Addendum Addenda

No./No 1

Project Description / Description de projet M50 Epitaxy Lab- HVAC Replacement and New Exhaust System/M50 Laboratoire Épitaxie amélioration		
Project No./No de projet 5746	Departmental Representative / représentant ministériel Allan Smith	Date 8-Apr-2021
Solicitation No./N° de sollicitation 20-58135		
Notice: This addendum shall form part of the tender documents and all conditions shall apply and be read in conjunction with the original plans and specifications.		
Nota: Cet addenda fait partie intégrale des dossiers d'appel; toutes les conditions énoncées doivent être lues et appliquées en conjonction avec les plans et les devis originaux.

- 12 Drawing M03:

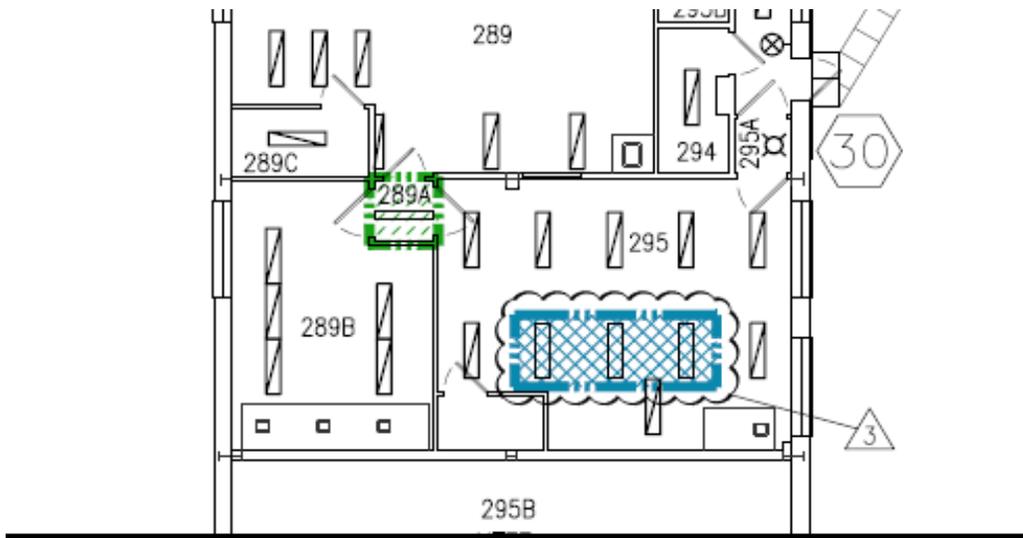
Note 8: Add the following: Nitrogen piping should be installed by Authorized MED GAS Contractor.

Note 9: Delete the note and replace with the following: KF Stainless Steel piping and KF clamps will be provided by NRC and installed by the contractor (piping are cut and welded and ready for installation). Contractor is responsible for the adequate piping supports.

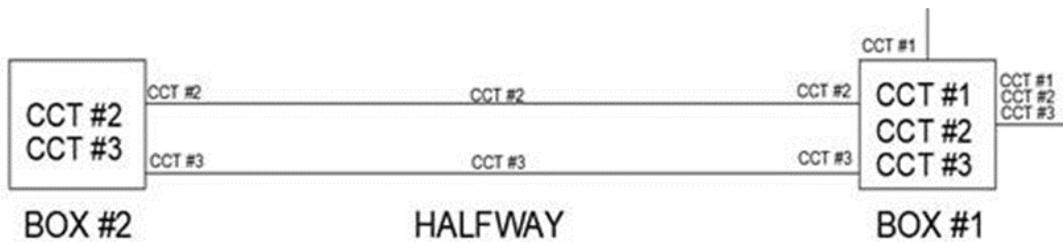
- 18 Provide conduit/cable identification:
- Identify all electrical circuits in every junction box and pull box on the box cover with 9mm letter size P-touch label. Identify all electrical circuits on each conduit end where conduit penetrates a wall ,enclosure ,junction box or pull box , and halfway of each conduit run between walls ,enclosures ,junction boxes or pull boxes with 3mm letter size P-touch label..
 - Identify electrical circuit on each cable 250MCM or larger with lamacoid nameplate, or cable 4/0 or smaller with P-touch label, on every splitter, every 30m of each cable run and cable end where cable penetrates a wall, enclosure, junction box or pull box.
 - Sample diagram shown as below:
